**ROGERS MS CENTRAL KITCHEN
A#03-124869
ADDENDUM 1 NARRATIVE**

AS REVISED
ADDENDUM 1
DSA #03-124869

LESD WILL ROGERS MS CENTRAL KITCHEN HVAC UPGRADES
LAWDALE ELEMENTARY SCHOOL DISTRICT
4110 W 154TH ST., LAWDALE, CA 90260

MECHANICAL PIPING
DIAGRAM

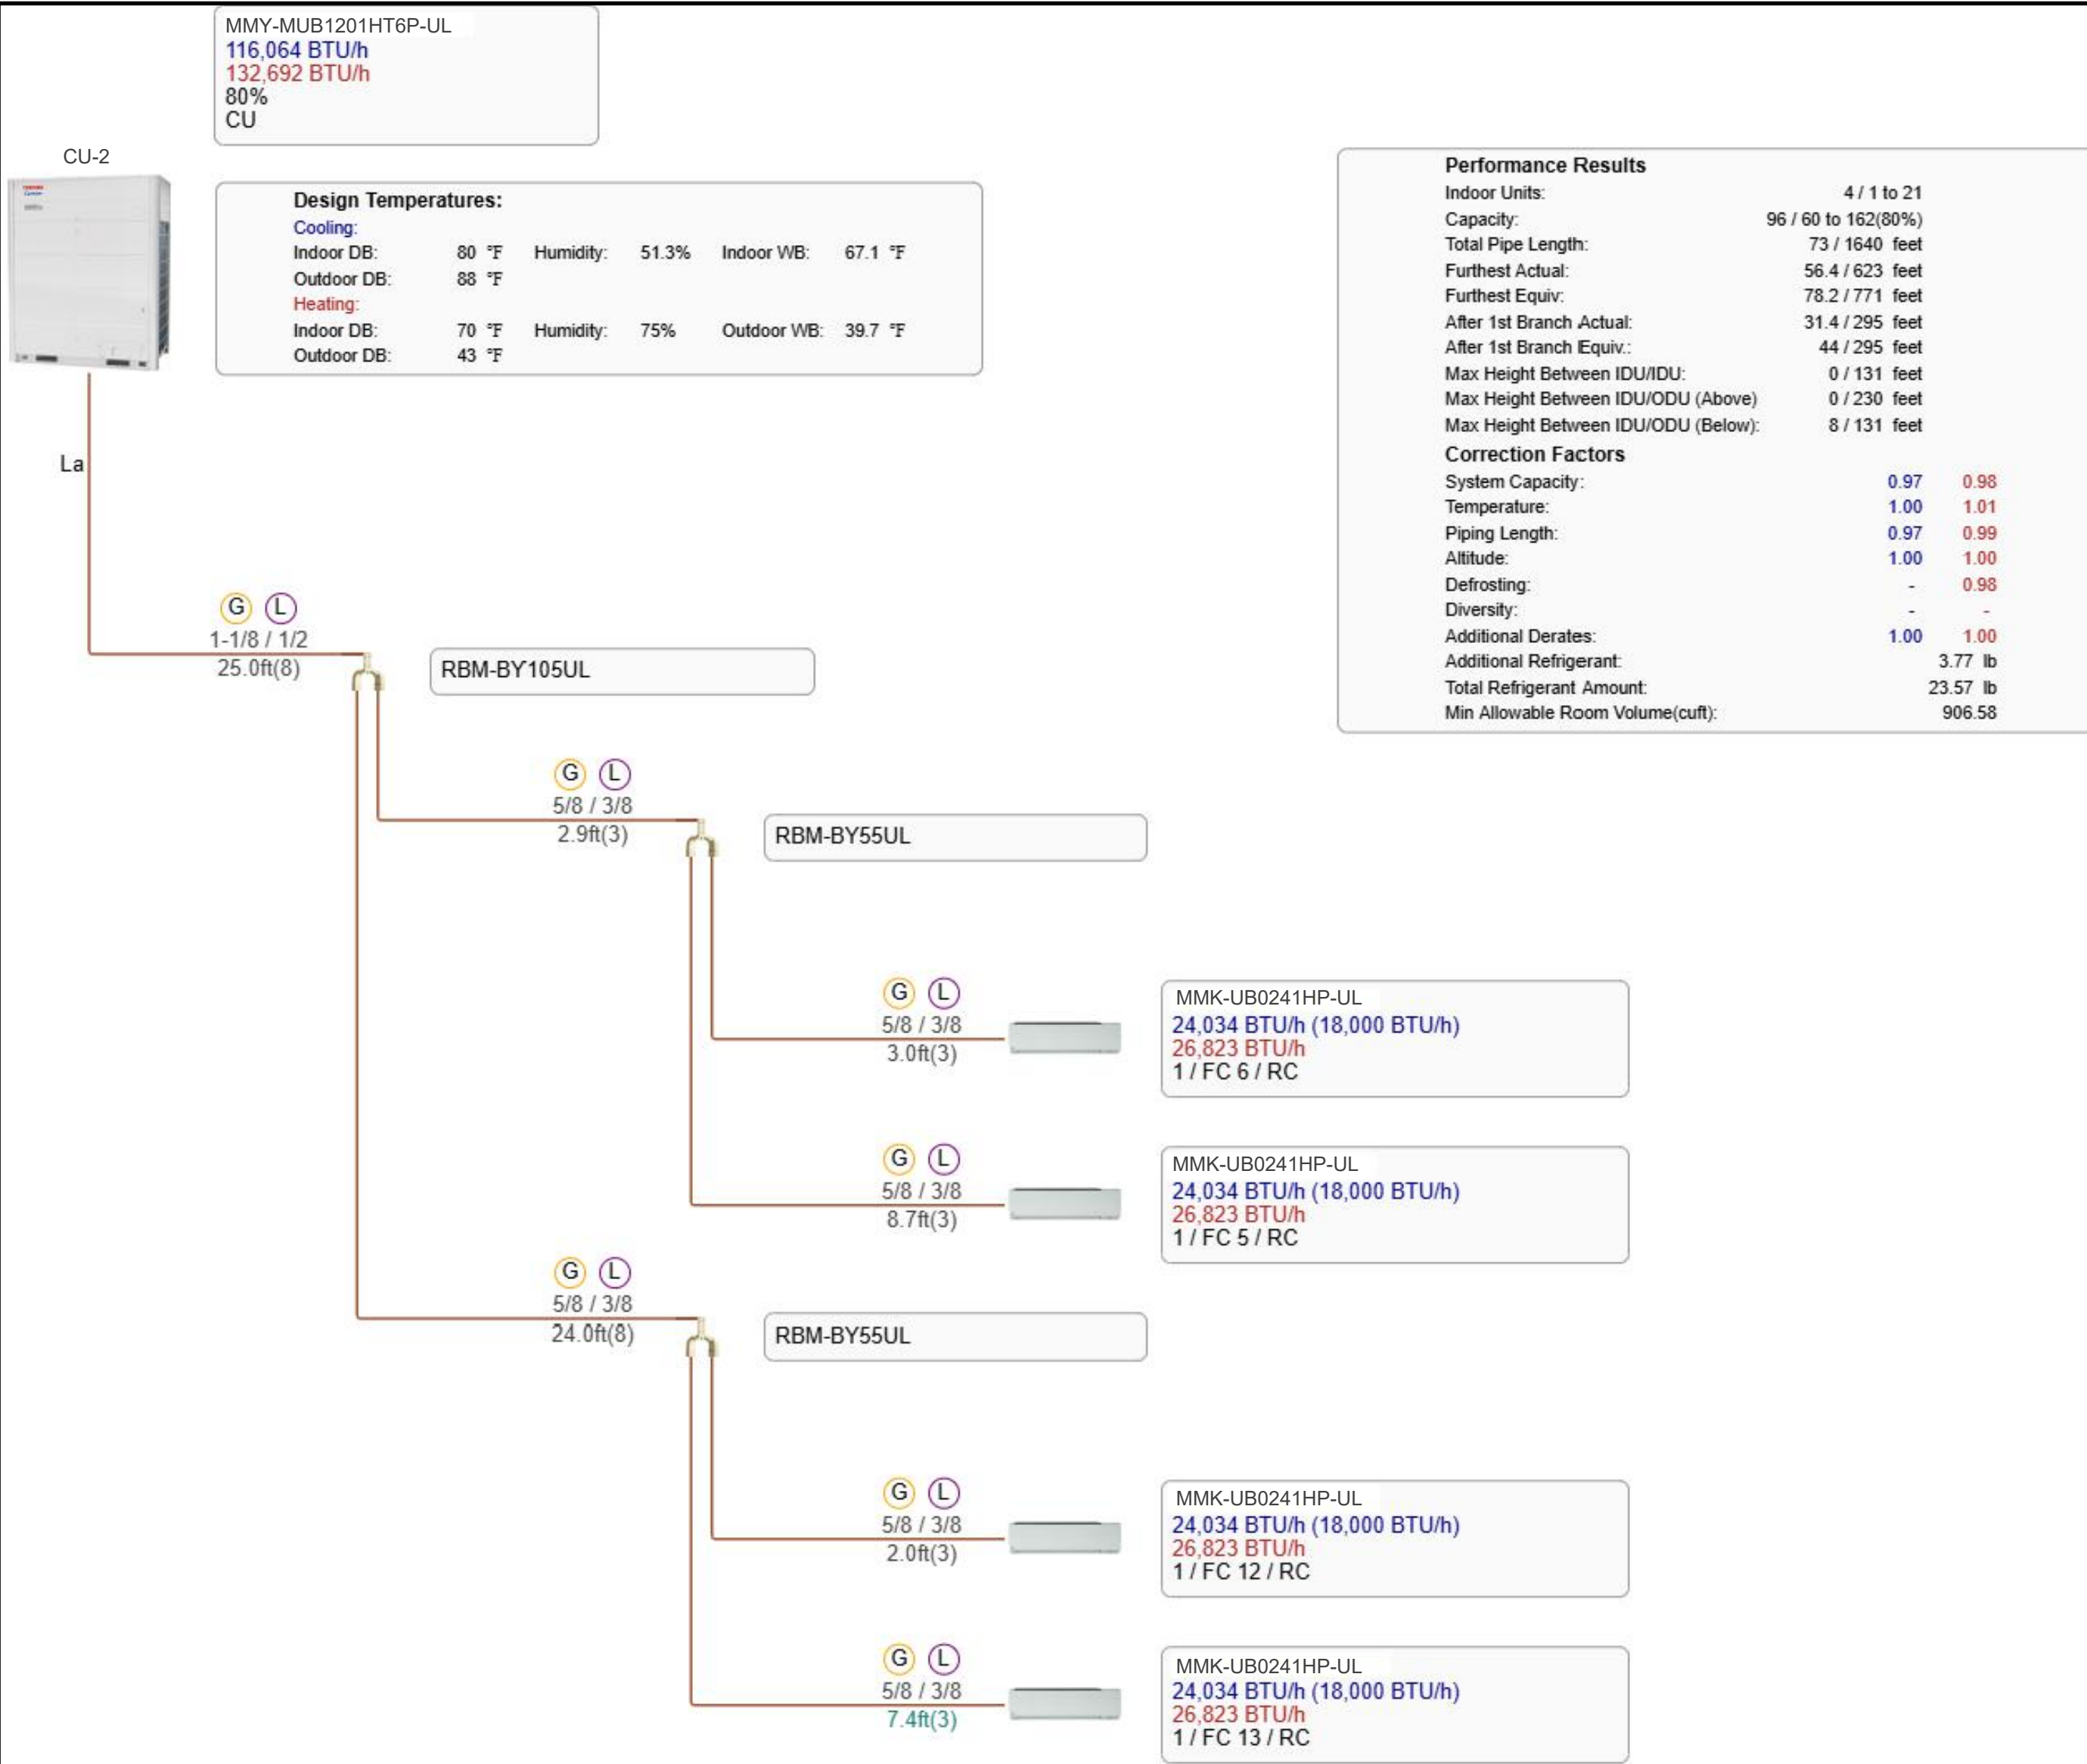
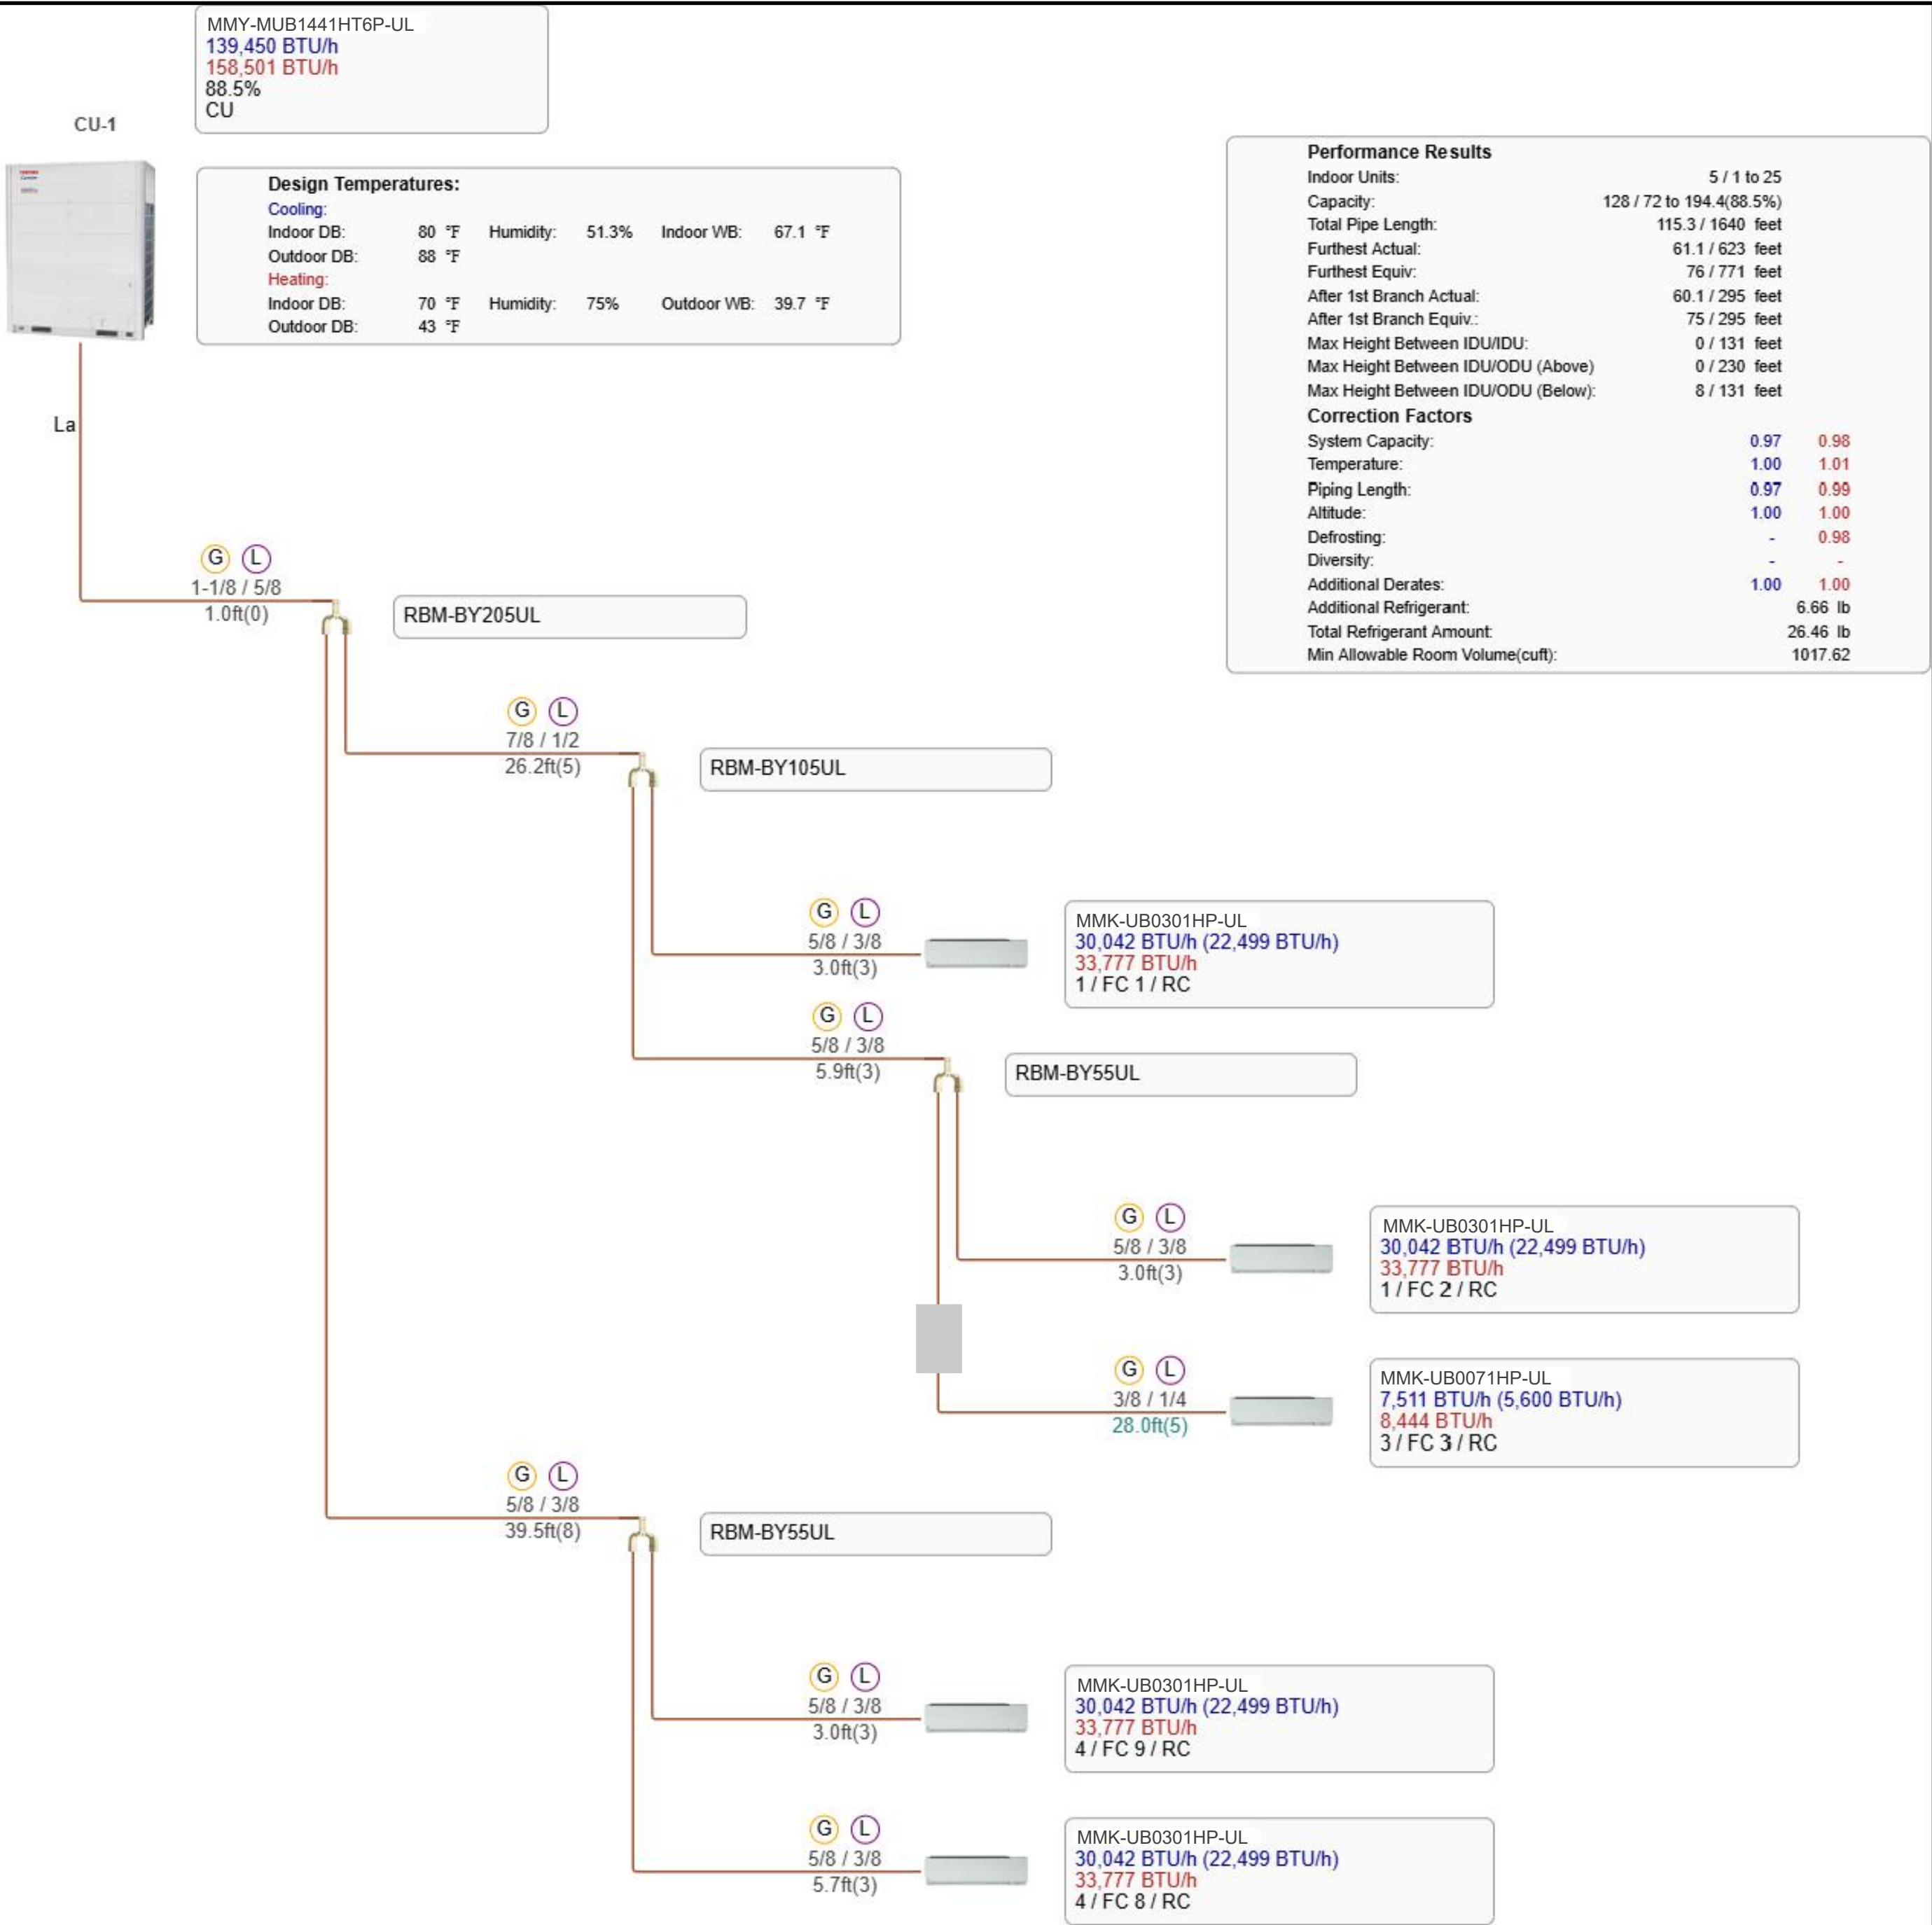
- a) Revised refrigerant piping diagram.

ELECTRICAL
ENLARGED SITE PLAN

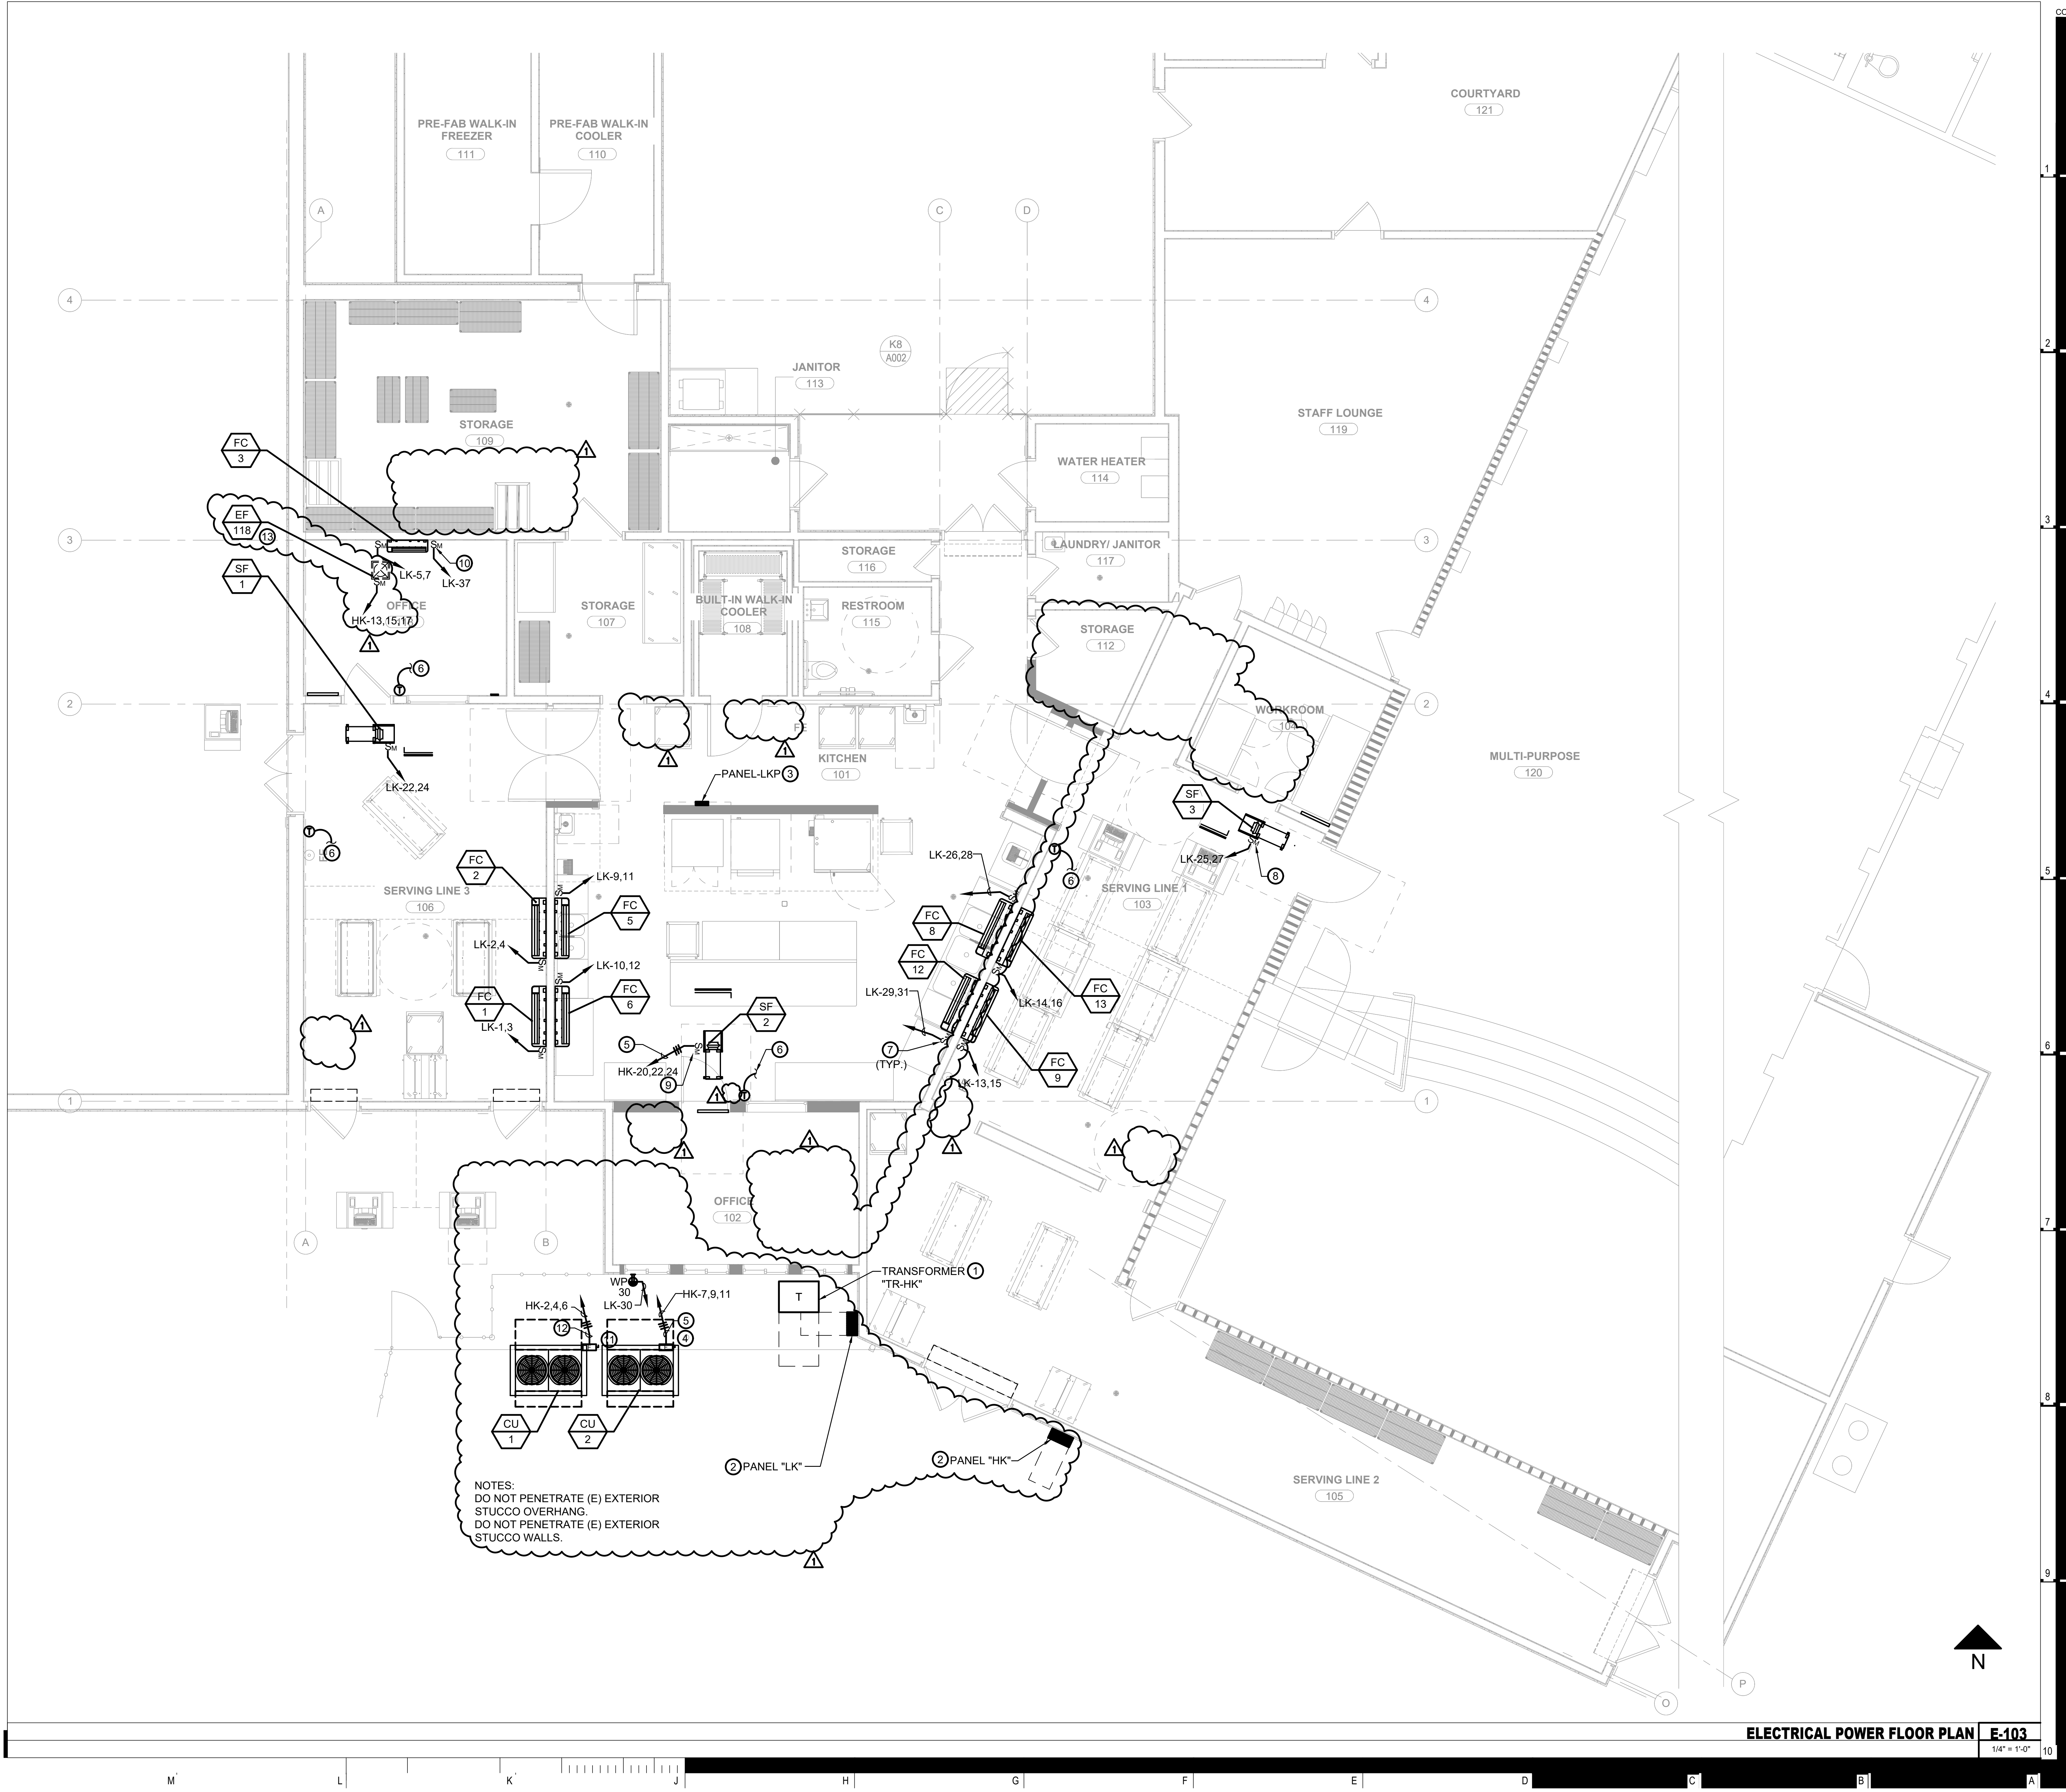
- a) Revised location of 3" conduit drop through the roof into Serving Line 2 to feed Panel 'HK'.
- b) Revised conduit to be EMT conduit.
